PLAN COMMISSION MEETING

Re: Sandy Bay Highlands Subdivision No. 3
Final Plat Comments

MULTI-FAMILY RESIDENTIAL DEVELOPMENT
3000 FOREST AVENUE
CITY OF TWO RIVERS, WISCONSIN

SITE LIGHTING PLAN

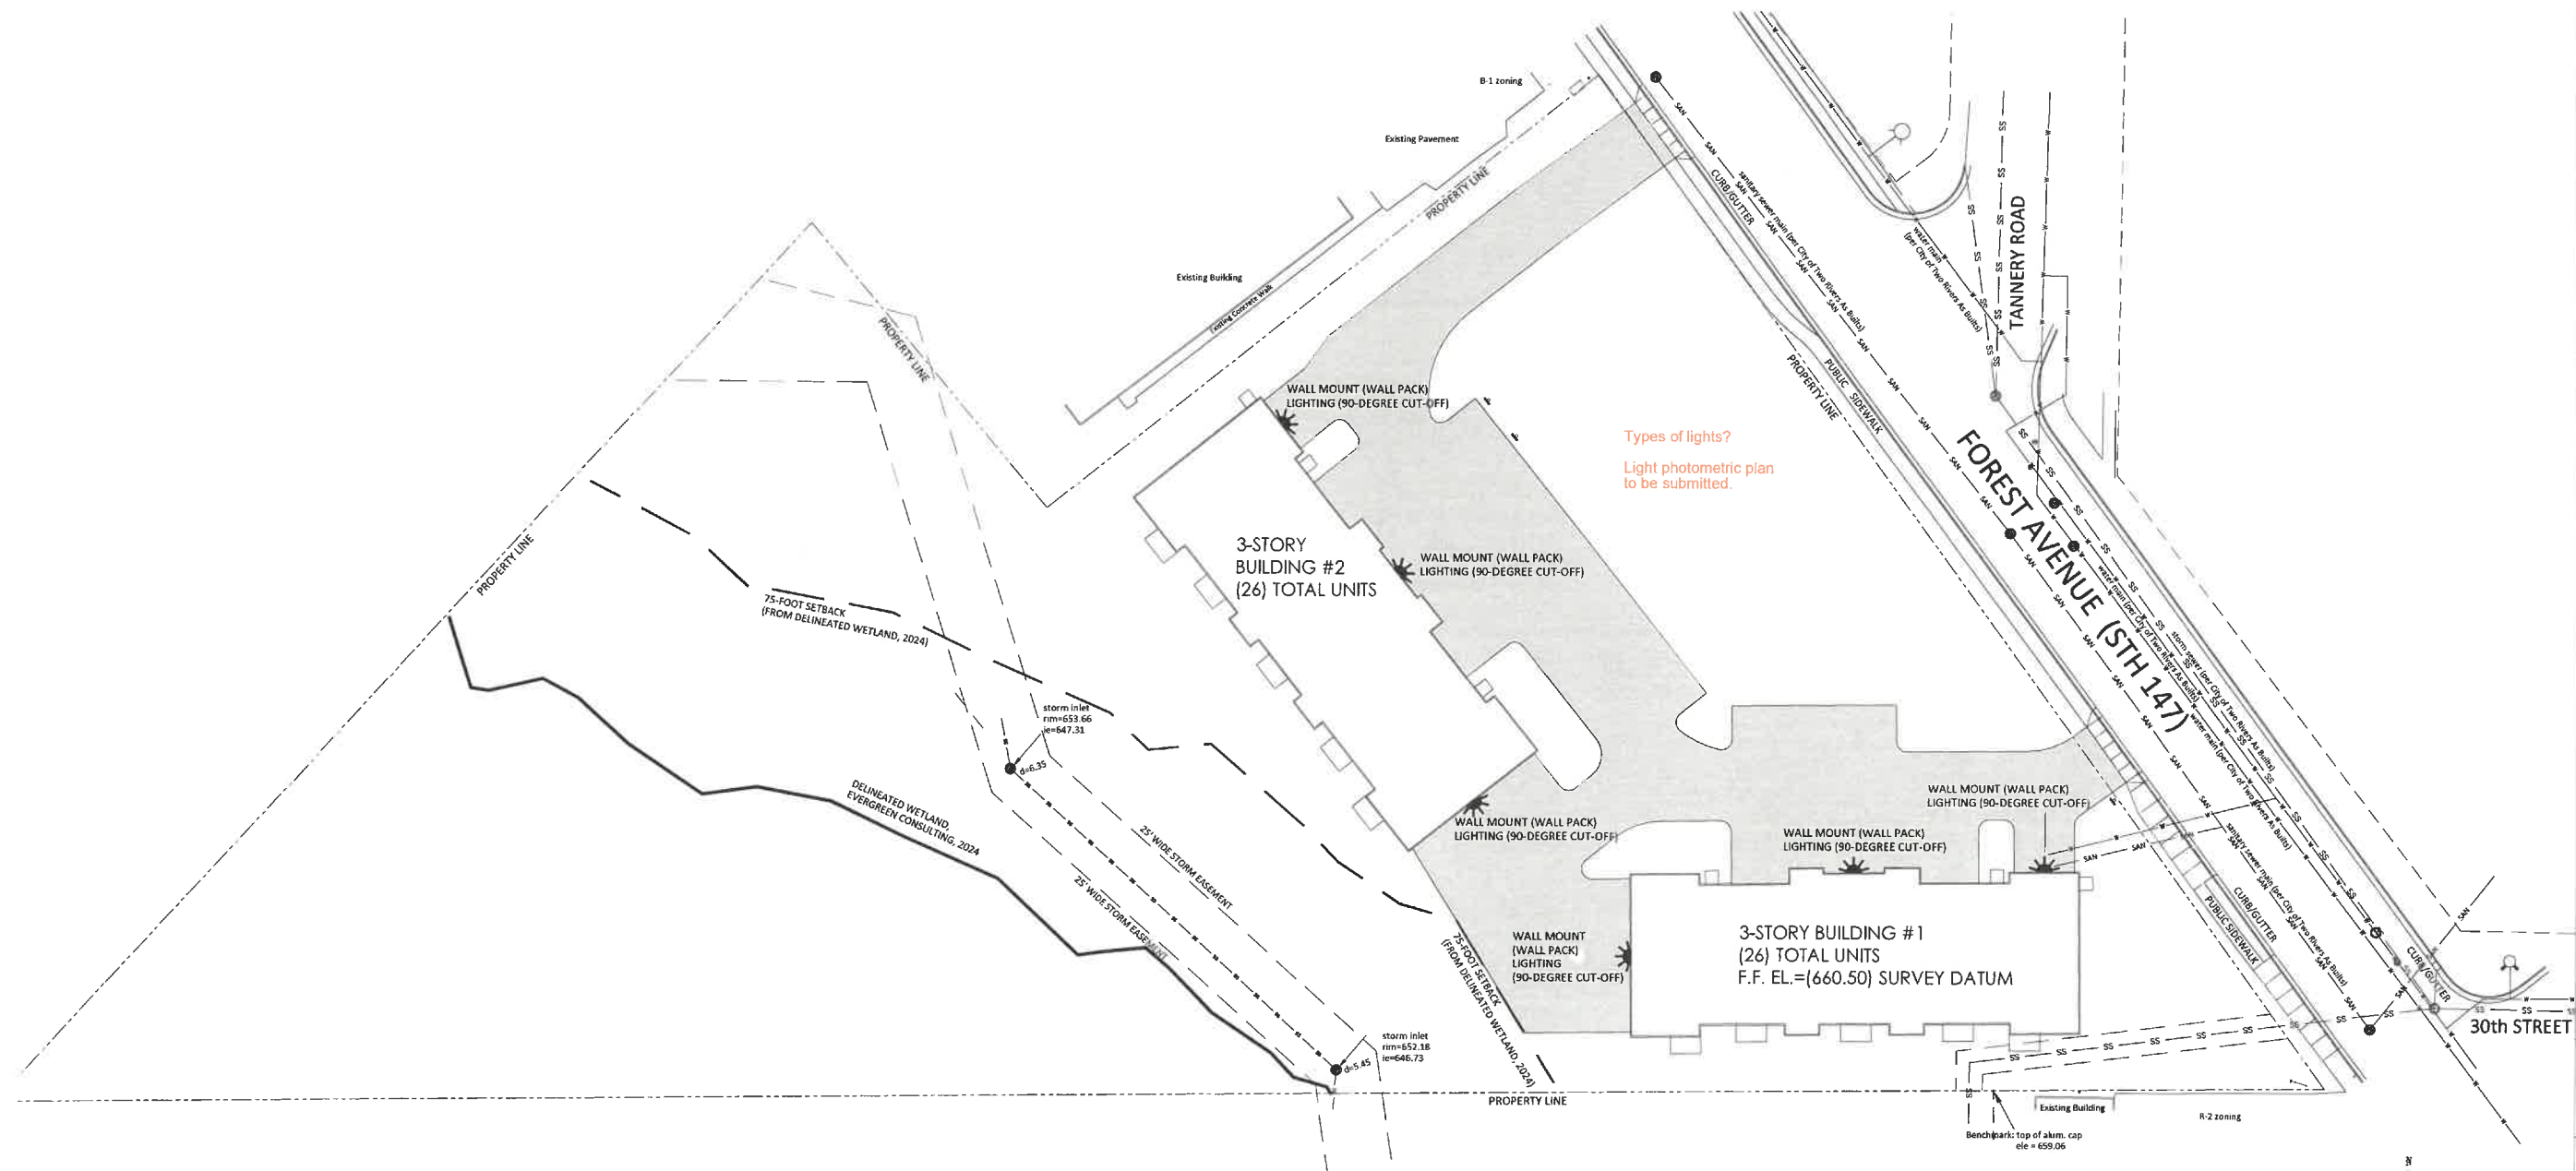
Provide type of lighs along with photometrics
